Creigiau & St. Fagans: Heol Pant-Y-Gored: Highway Improvements

Consultation Report

A consultation was held on the above scheme proposals between 4th January 2019 and 25th October 2019. 40 individual responses were received. The concerns and comments received are summarised as below, along with the Council's response.

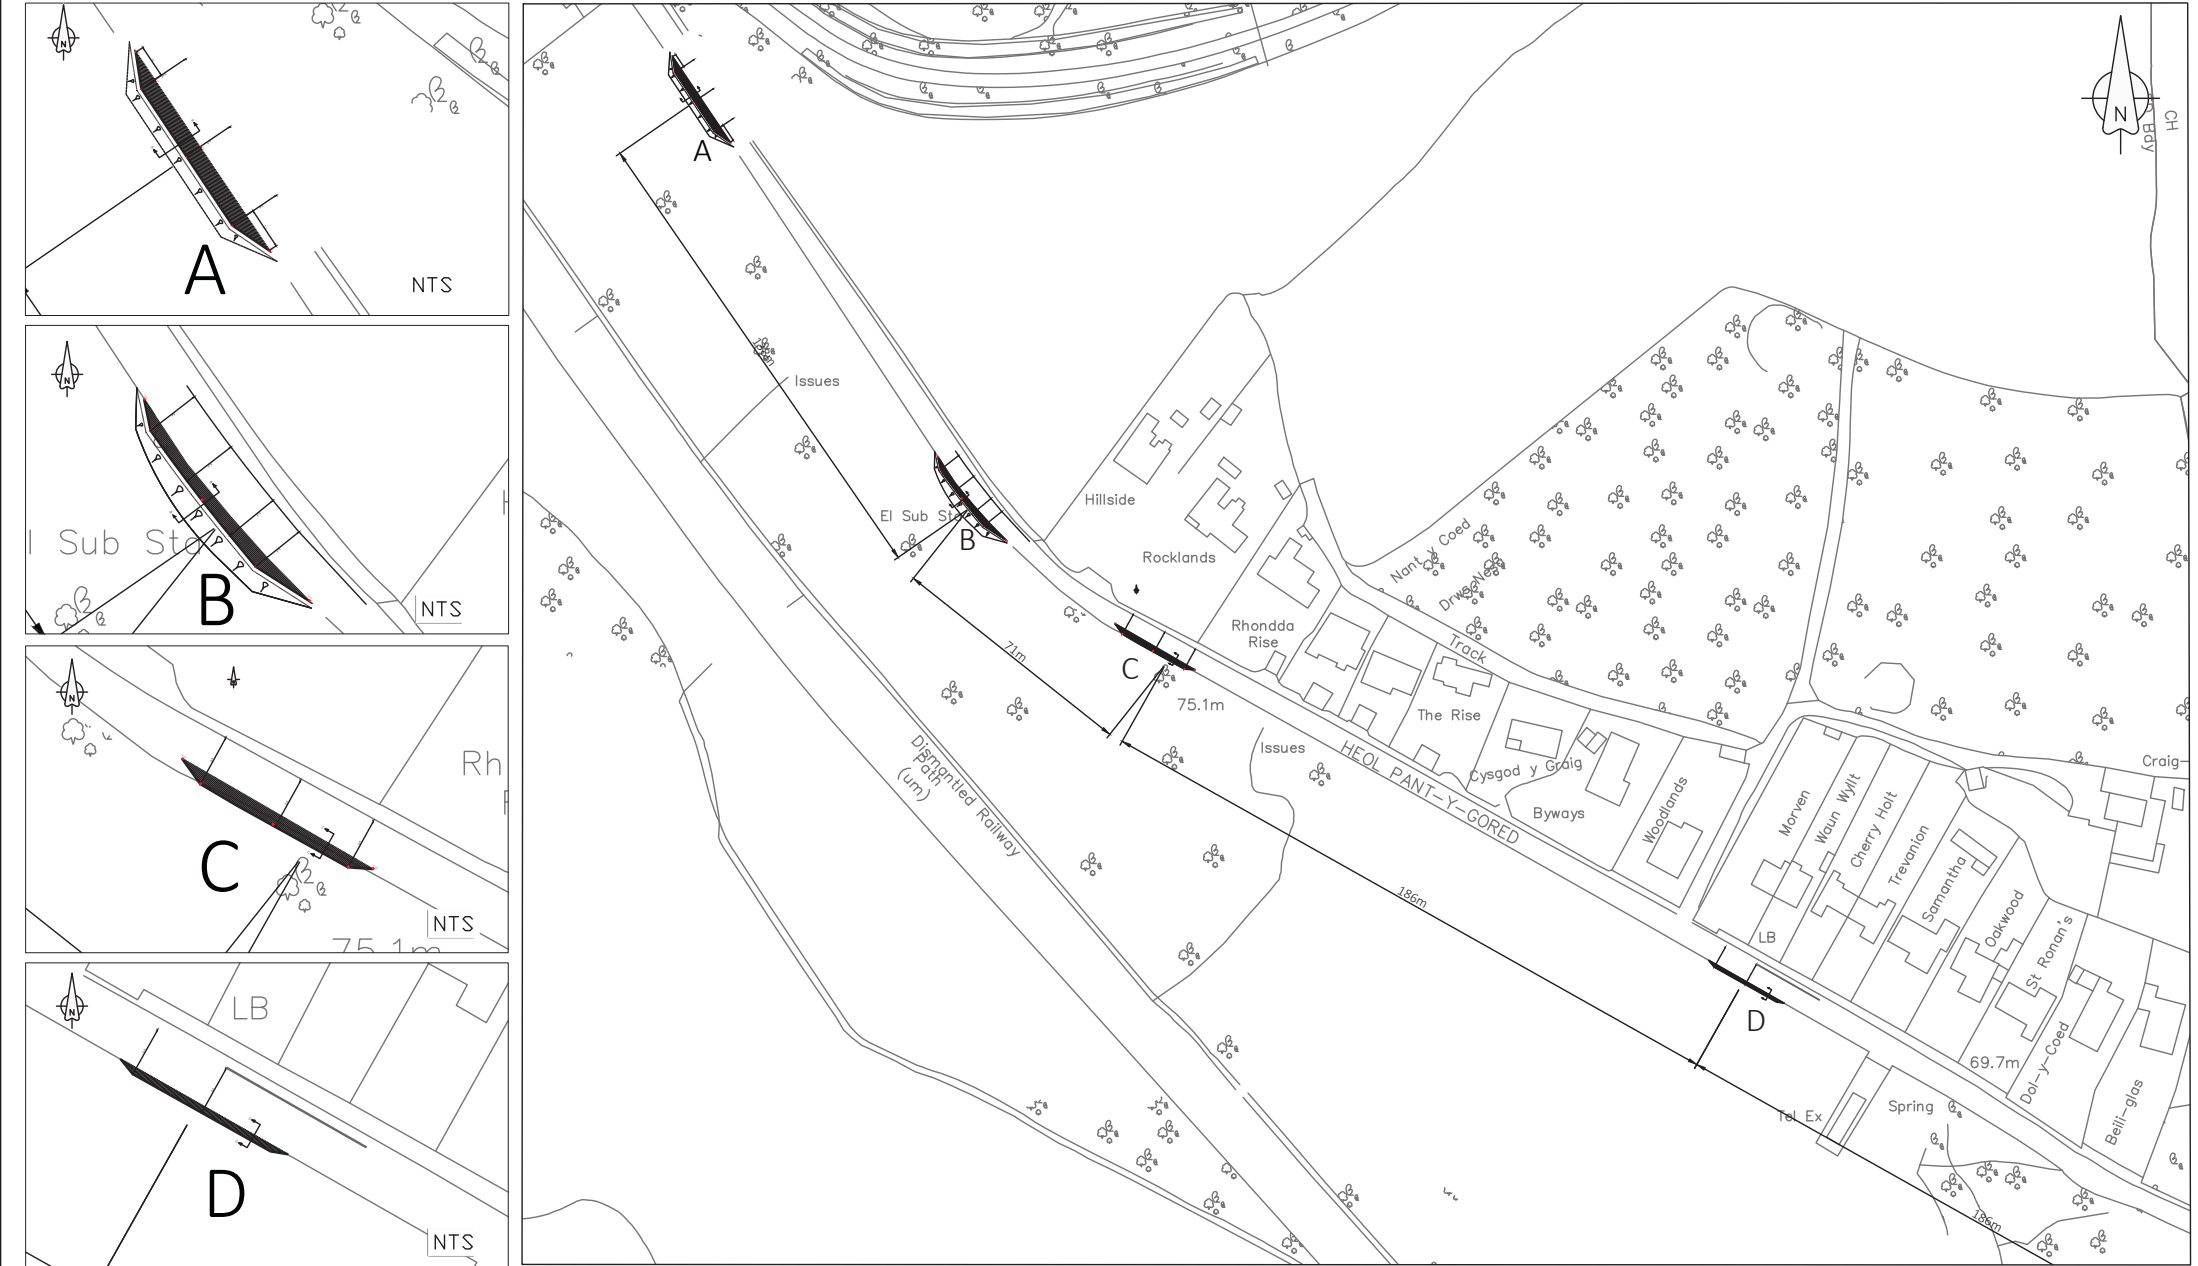
A number of respondents queried the location of the four passing bays, and whether additional bays should be provided on the road leading to Robin Hill.

The bays will be 6.3m wide and 20m in length, which is sufficient width for two large vehicles (including coaches) to pass each other. The passing places will also include tapers on approach and on exit in order to facilitate the movement of vehicles into and out of the localised widening. The passing bays are not intended to be used for multiple large vehicles at one time, they are designed to allow one large vehicle to pass another at the location of the widening. Passing places are often provided on rural roads on a permanent basis to accommodate passing traffic.

The locations of the passing bays have been chosen in order to maintain forward visibility between the bays, particularly near the bend. This will ensure that approaching motorists have the opportunity to wait within a passing place when they see an oncoming vehicle.

The section of the road from Pant y Gored farm to the junction with Cardiff Road is wider (in part) than the section of road where the passing places are being provided, and will therefore accommodate two large vehicles passing without the need to provide additional passing places.
